PLANNING REPORT

PLANNING AND ZONING COMMISSION

DECEMBER 10, 2009

1. Kumon Learning Center **4056 West Dublin-Granville Road**
09-067Z/PDP **Rezoning/Preliminary Development Plan**

RELATIONSHIP OF PROPOSAL TO SHAMROCK CROSSING APPROVED PRELIMINARY DEVELOPMENT PLAN & ADJACENT PROPERTY

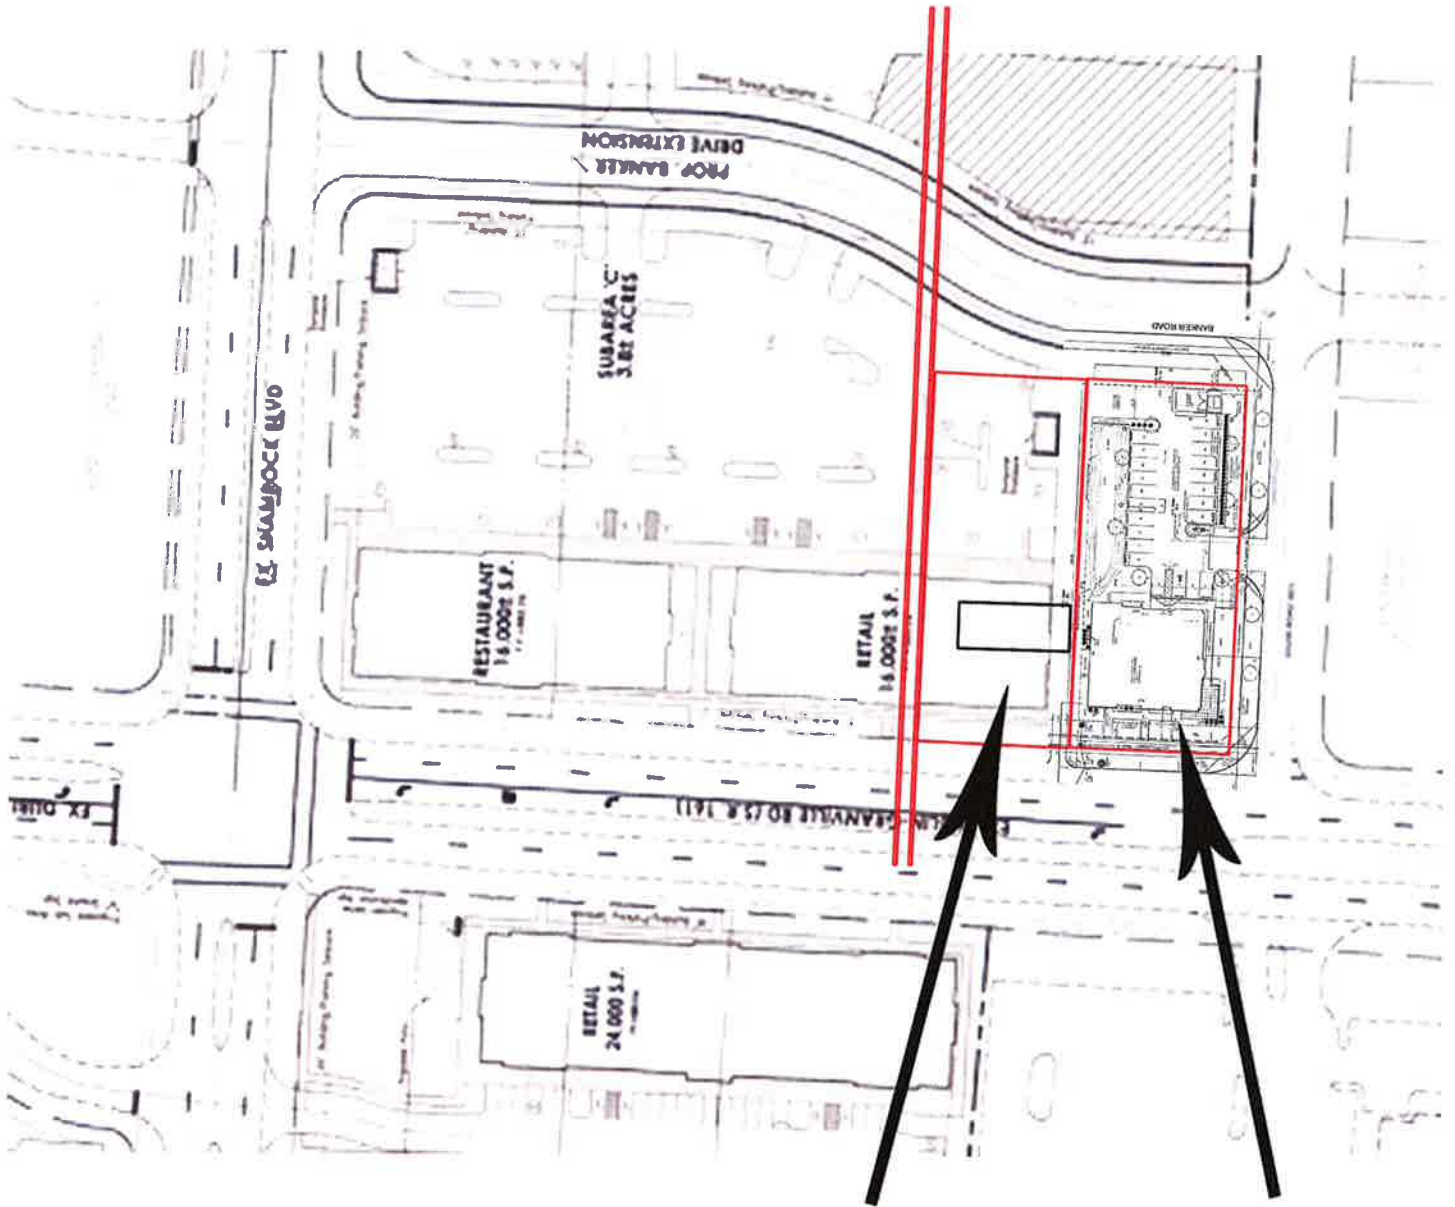
At the October 8, 2009 meeting, the Planning and Zoning Commission members expressed concerns with the relationship of this site to the adjacent parcel to the west (4070 West Dublin-Granville Road) and whether development on this site would negatively affect development on the adjacent parcel. Testimony was provided stating that although the property at 4070 West Dublin-Granville Road was rezoned as part of the Shamrock Crossing preliminary development plan, the property was still privately owned and occupied. It was noted that one of the challenges with developing the property at 4070 West Dublin-Granville Road was a 10-foot wide easement located along the western property line on the adjacent parcel to the west.

Although the existence of the easement does not preclude development on the adjacent parcel, it may limit the future building location. It is Planning's opinion, however, that the size of the parcel (0.55-acre), which is comparable to the proposed Kumon Learning Center site, will still be developable even if buildings cannot cross the easement (see attached exhibit).
